RANCOCAS VALLEY REGIONAL HIGH SCHOOL DISTRICT
Renovations at the
Rancocas Valley Regional High School District Annex
Addendum #1
January 13, 2020

Bid Package Clarification and Changes

TITLE PIPE DETAIL
SHEET NO. SKM-02
DATE 01/07/2020 JOB NUMBER 5918
SCALE NO SCALE

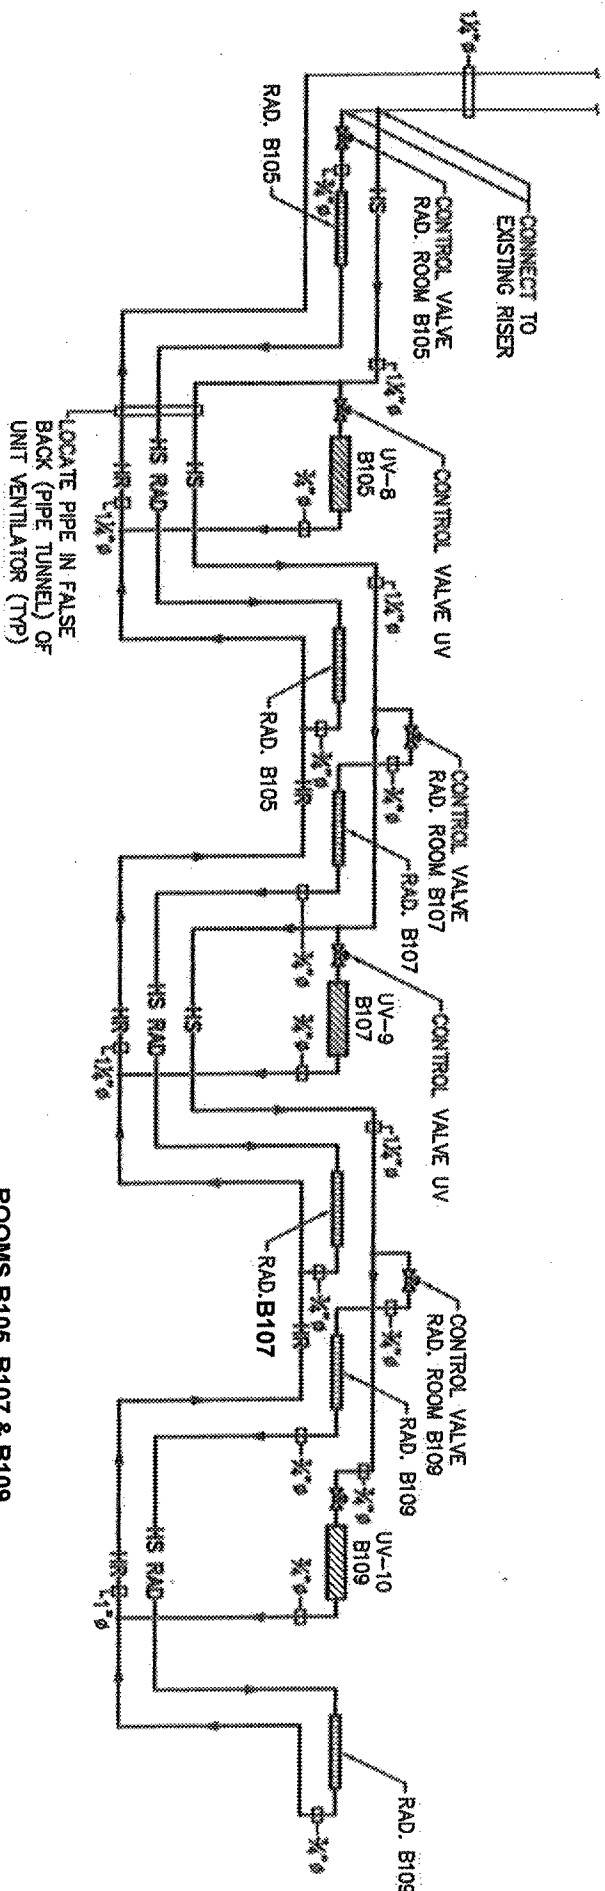
- e. Room B105; Add H Symbol at room thermostat (Similar to adjacent classrooms).
 - f. Rooms B105, B107 & B109; Add new piping detail per **attached sketch SKM-02**.

- b. Rooms B114, B116 & B118; Add new piping detail per **attached sketch SKM-02** (Similar).
16. On Drawing M4.1, Mechanical Schedules; include the following changes:

LOCATE PIPE IN FALSE
BACK (PIPE TUNNEL) OF
UNIT VENTILATOR (TYP)

ROOMS B105, B107 & B109
PIPING DETAIL SIMILAR FOR ROOMS
B114, B116 & B118.
